**World Forum for Harmonization of Vehicle Regulations****Working Party on Lighting and Light-Signalling****Ninetieth session**

**Installation UN Regulations: UN Regulation No. 48 (Installation of lighting and light-signalling devices)****Proposal for a Supplement to the 06, 07 and 08 series of amendments to UN Regulation No. 48****Submitted by the experts from the International Automotive Lighting and Light-Signalling Expert Group \***

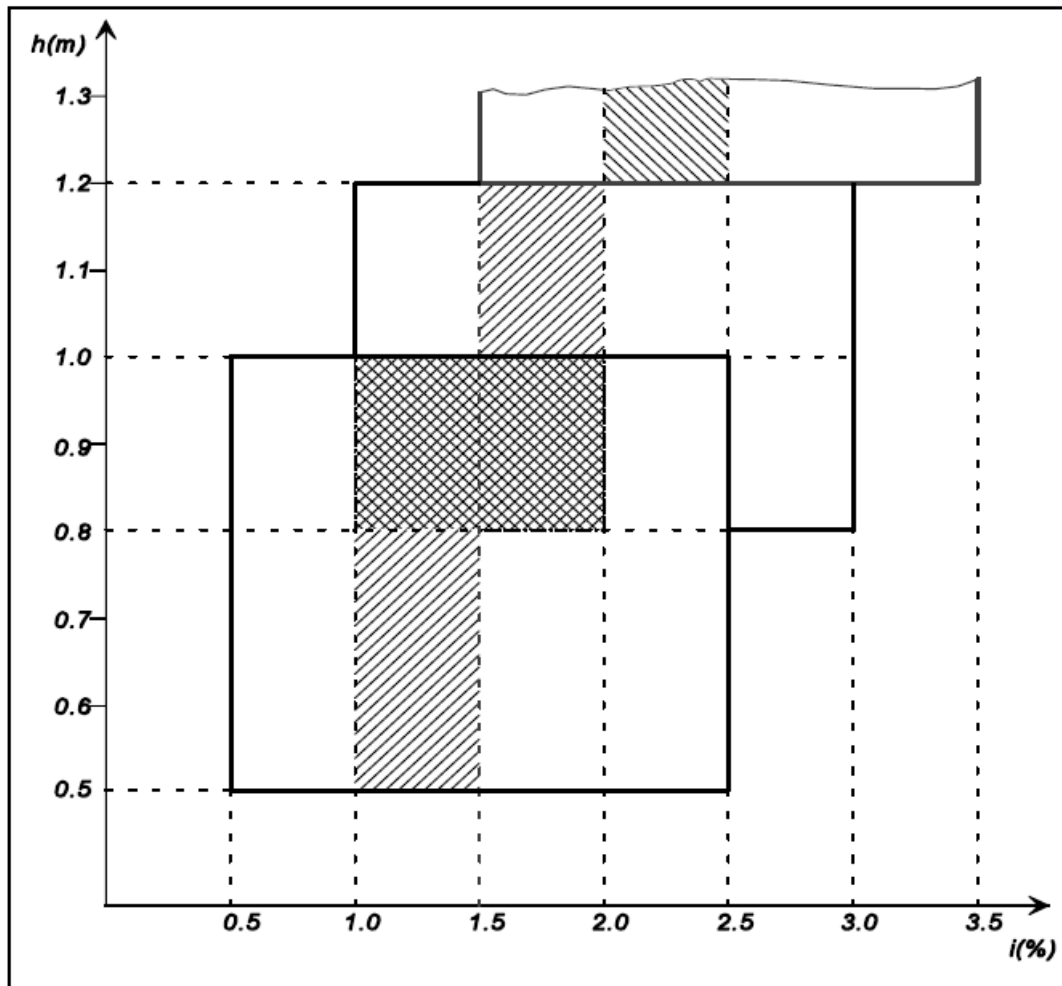
“6.2.6.1.2. Depending on the mounting height in metres (h) of the lower edge of the apparent surface in the direction of the reference axis of the dipped-beam headlamp, measured on the unladen vehicles, the vertical inclination of the cut-off of the dipped beam shall, under all the static conditions of Annex 5, remain between the following limits and the initial aiming shall have the following values:

For category **N<sub>2</sub>G**, **N<sub>3</sub>G**, **M<sub>2</sub>G**, **M<sub>3</sub>G** (off-road) vehicles where the headlamps exceed a height of 1,200 mm, the limits for the vertical inclination of the cut-off shall be between: -1.5 per cent and -3.5 per cent.

The initial aim shall be set between: -2 per cent and -2.5 per cent.
